Remarks

Amendments to the Drawings:

The attached sheets of drawings include changes to Figs. 7 and 12. These sheets, which include Figs. 7, 12A and 12B, replace the original sheets 7 and 12 of the original drawings. In Fig. 7, previously omitted element 171 has been added. In Fig. 12, the sheet has been changed to separate Fig. 12 into Fig. 12A and Fig. 12B.

FIG. 12B

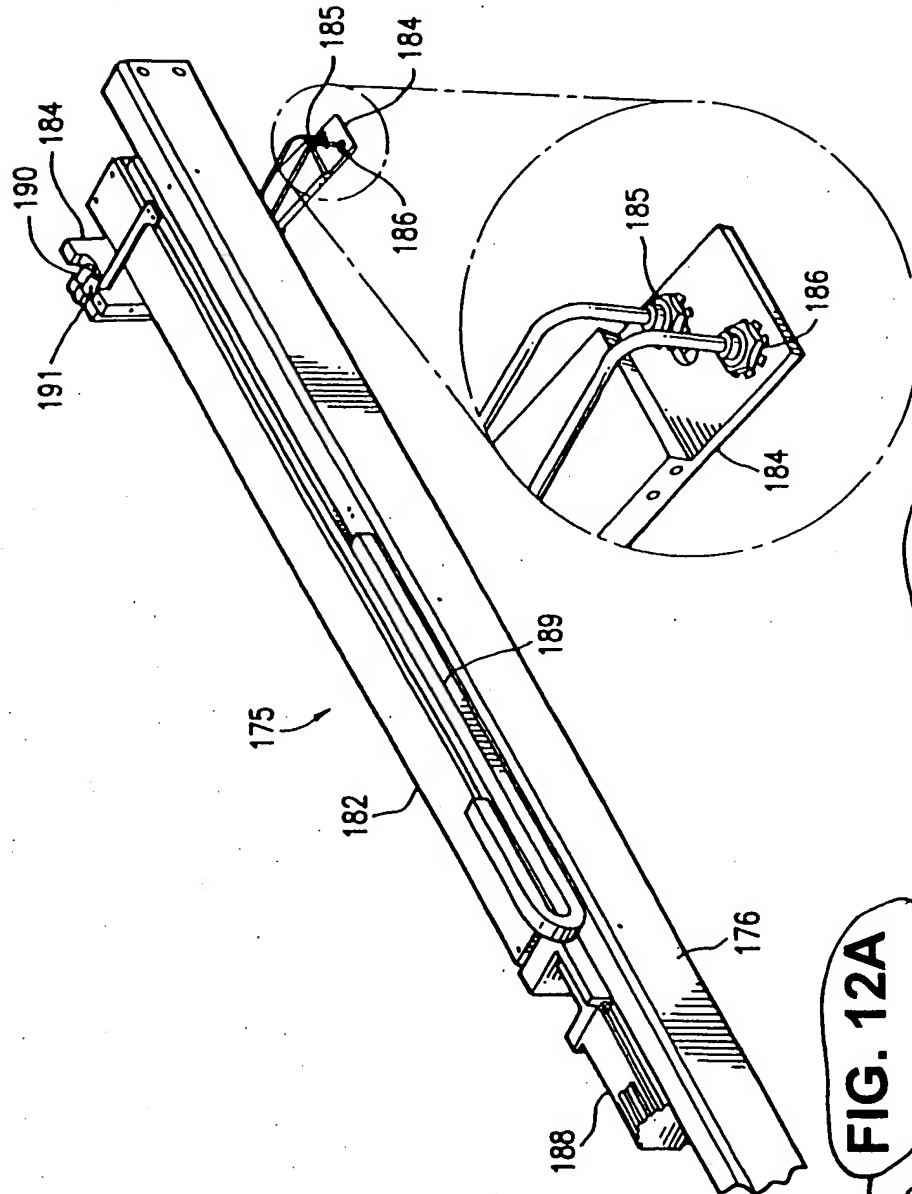
caption
added

caption
added
